Statement of Response to An Bord Pleanála Opinion

Proposed SHD

**Lands at The Grange,
Brewery Road/Stillorgan Road,
Stillorgan, Blackrock,
Co. Dublin**

This report is a response to the issues raised by An Bord Pleanala following the pre-application process for Strategic Housing Development planning application on the subject site. ABP Pre-Application Reference ABP-304147-19 refers.

Figure 1 - Modulation of Heights along Brewery Road

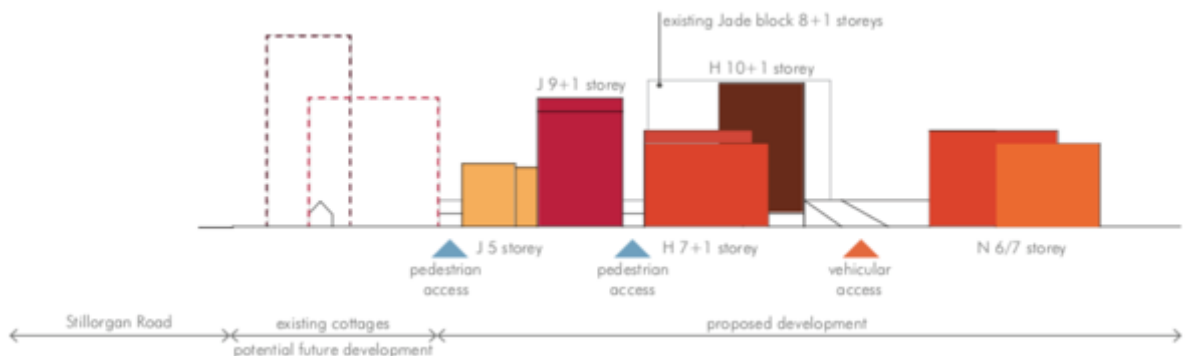
A report including CGIs, visualisations and cross sections, as necessary, which clearly show the relationship between the proposed development and the existing development on Brewery Road. Details should include rationale/justification for the heights and set backs proposed; the interface between the proposed development and Brewery Road; boundary treatments; public realm and ground floor elevational treatments. Details should also be included of the relationship between the proposed heights and any future development on adjacent lands at the junction of the N11/Brewery Road.

- “The heights along Brewery Road are carefully modulated.
- The buildings are designed as a series of pavilions of varying height and width, with the break in volume indicating points of entry.
- Two wide lower blocks (H and N, 7 storey) frame the entrance road, redefined as the development’s new front door.
- Tallest block along the road (J, 9+1 storey) sits where distances to houses of Woodward Lawn is greatest (65m).
- Small element of block J is of reduced scale (5 storey) to mitigate impact on existing cottage not in the ownership of the applicant.”

It is evident from the above, that the heights proposed in this case have been carefully considered and it is the view of the applicant and design team that the site can successfully absorb the heights proposed. It is evident due to the change in levels across the site, the new proposed Block H sits in line with the existing

Figure 10 - Separation Distances to the Existing Grange Development

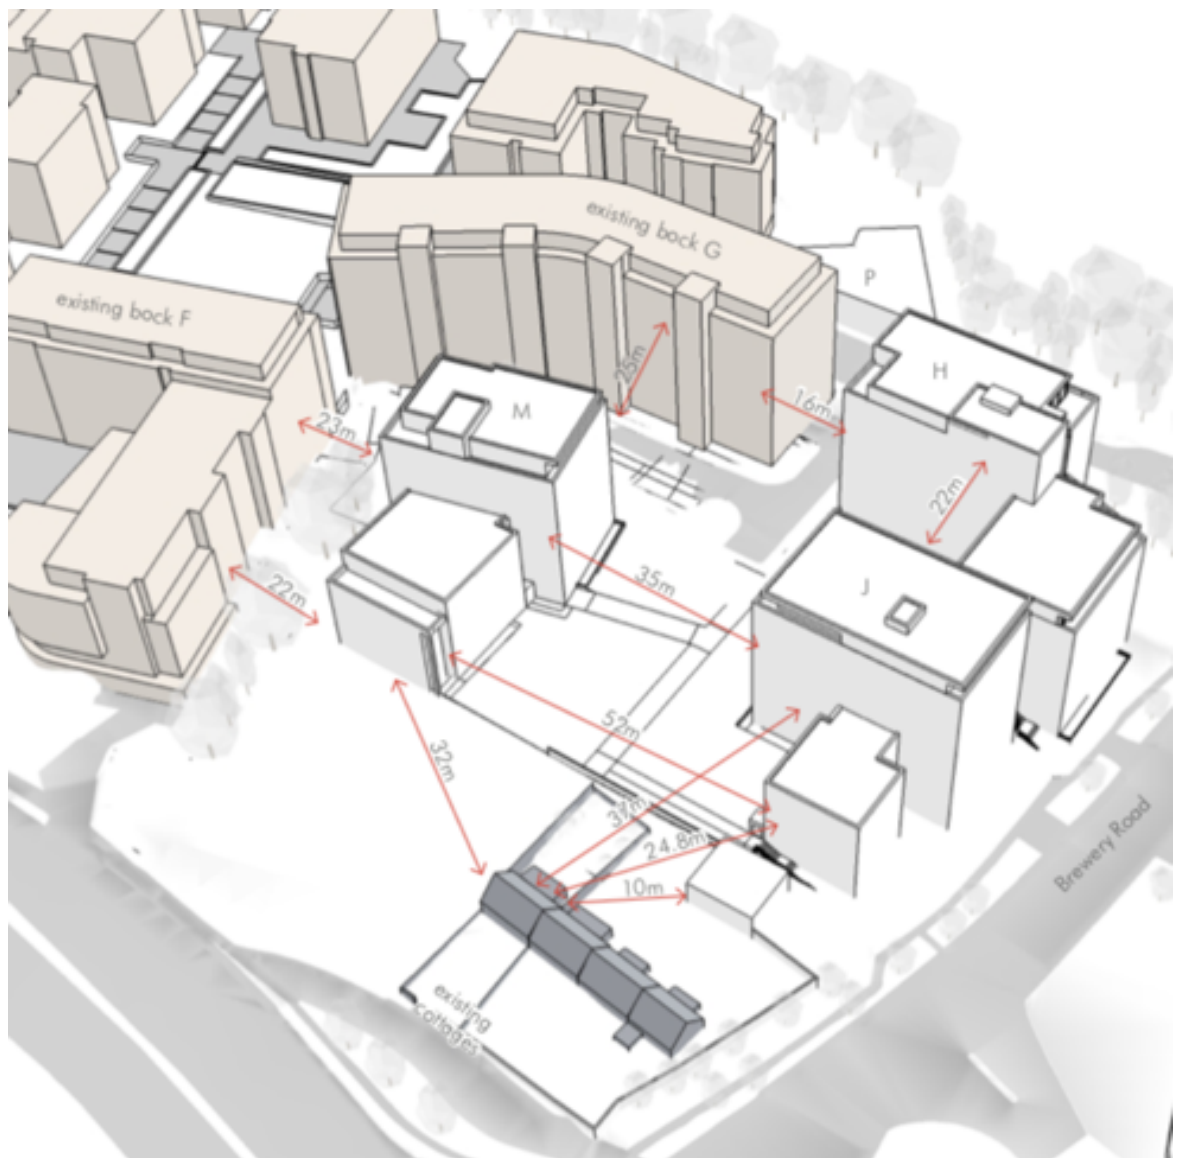
A report that addresses issues of residential amenity (both existing residents of adjoining development and future occupants), specifically with regards to overlooking, overshadowing, overbearing and noise. The report shall include full and complete drawings including levels and cross sections showing the relationship between the proposed development and adjoining residential development. Furthermore, landscape and architectural drawings that clearly detail the relationship between wind impact mitigation measures and the design of the proposed development shall be included.

The following figure sets out a summary of the various separation distance relationships:

We can confirm that there are no instances of direct overlooking which have a separation distance of less than 22m within the development.
